**Q1:** The introduction would benefit from a brief description of what the parts of the inlet system/aerodynamic lens are and what each one does. such as the critical orifice, the buffer region, the apertures in the aerodynamic lens, etc. It would also help if the nomenclature is consistent between the figures and the text and between different parts of the text. Each part that is called out in the text should be labelled in Figure 1. For example, a virtual impactor is mentioned in line 139 but I can't tell if that is the same thing as the pre-focus hole or the buffer chamber in Figure 1 or something else entirely. Where is the critical orifice and what diameter is it?

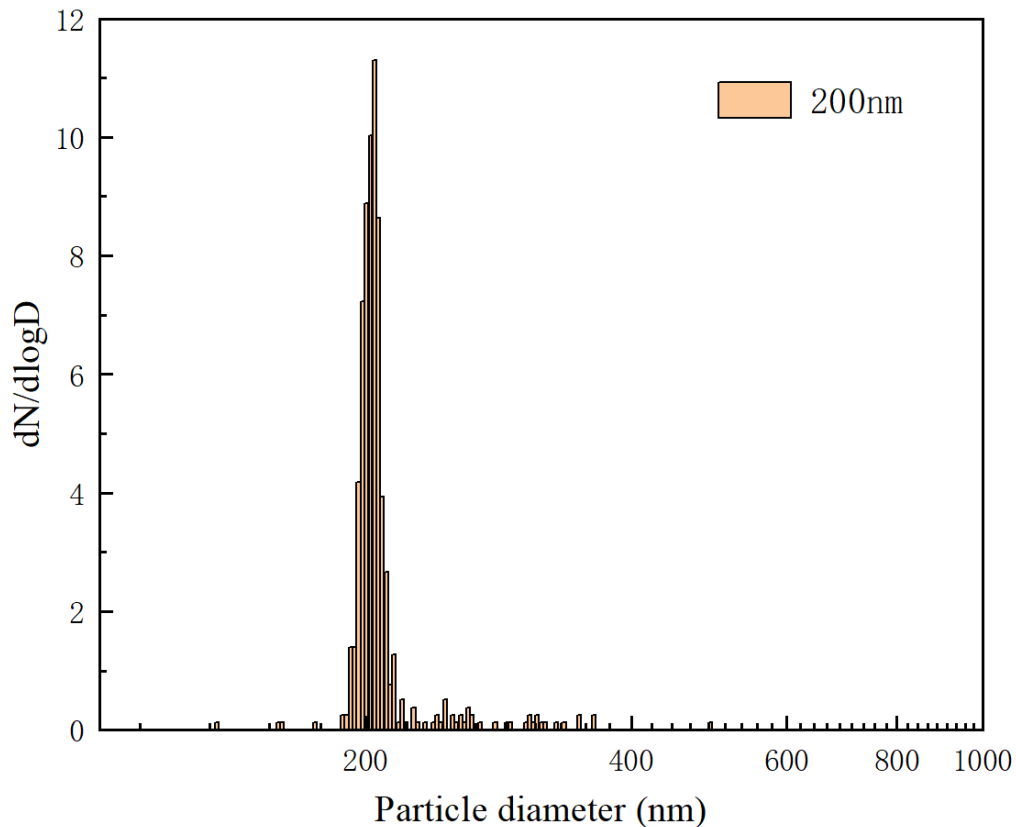
**Q3:** The authors mention multiple times that their goal is miniaturization of the SPAMS. Making the inlet smaller is not going to accomplish that. The size is really determined by the pumps and the mass spectrometers. It is ok to say that the goal is to extend the range of sizes transmitted by the inlet system.

**A3:** Thank you to the reviewer for the insightful suggestions. In fact, after utilizing the novel pre-focusing structure designed in this study, the width of the particle beam can be significantly reduced, allowing for the use of smaller buffer chambers and fewer stages of lenses. This reduction decreases the volume of the injection system. Since the radial length of SPAMS primarily depends on the volume of the injection system, I believe this will help in reducing the overall volume of the SPAMS instrument.
